# Access Compliance Report Public Rights-of-Way (Curb Ramps)

Main Street: SPRING\_VIEW\_WAY Cross Street: ELM\_PL Location: NE

ADA ID: RPRK211019140300 Ramp Type: Type 4 - Parallel Initial Pass/Fail: Fail Overall Compliance: No Severity Score: 30

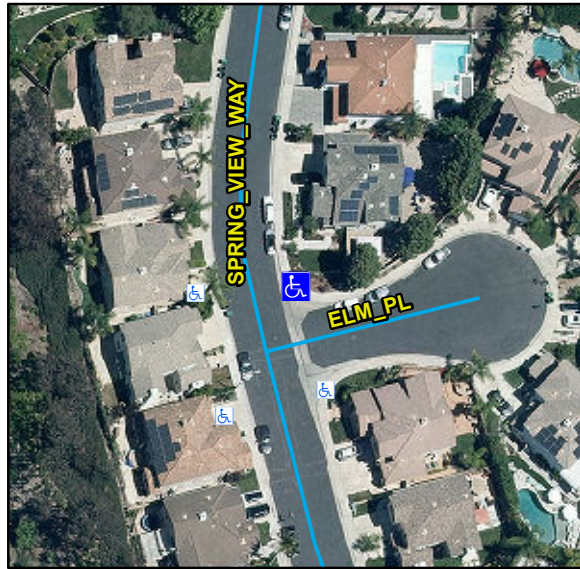
| Compliance | Description                   | Data       | Compliance | Description                   | Data |
|------------|-------------------------------|------------|------------|-------------------------------|------|
| No         | Ramp Cross Slope LT (%)       | 12.7       | No         | Ramp Cross Slope RT (%)       | 13   |

**Remove & Replace Curb Ramp With Two New Directional Ramps or Equivalent.**

**R204.3, R304.5.3, STD 1115**
